CONSTRUCTION SUMMARY

Red Oaks - Roundel Homes Inc.

LOT / PHASE 112 / 1	REG. PLAN # 65M-4737	HOUSE TYPE Pinetree 3 Elev 1		
------------------------	-------------------------	---------------------------------	--	--

Preliminary upgrades

# PineTree 3

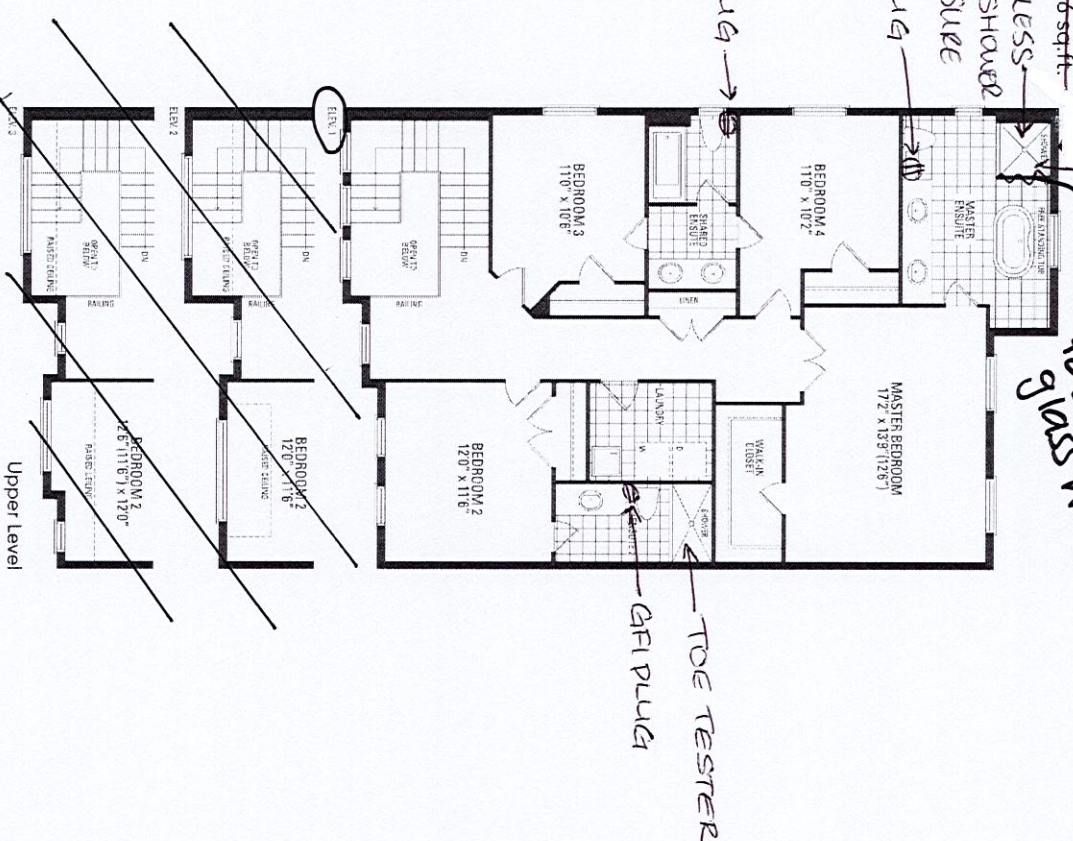
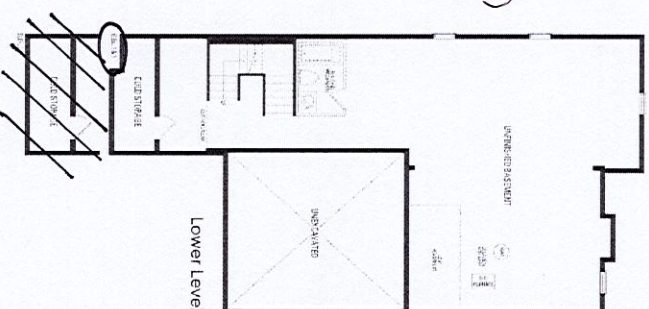
1 - FRAMELESS GLASS SHOWER ENCLOSURE PROVISION - REMOVE SIDE WALL AND REPLACE WITH GLASS TO ACCOMODATE FRAMELESS GLASS SHOWER ENCLOSURE SEE SKETCH 06Mar23 Note:	
1 - SMOOTH CEILINGS ON SECOND FLOOR ONLY 03Mar23 Note:	
1 - SMOOTH CEILINGS ON FIRST FLOOR ONLY 03Mar23 Note:

- \* SMOOTH CEILING FIRST + SECOND FLOOR
- \* WATERLINE R/I FOR FRIDGE
- \* GAS LINE R/I FOR STOVE
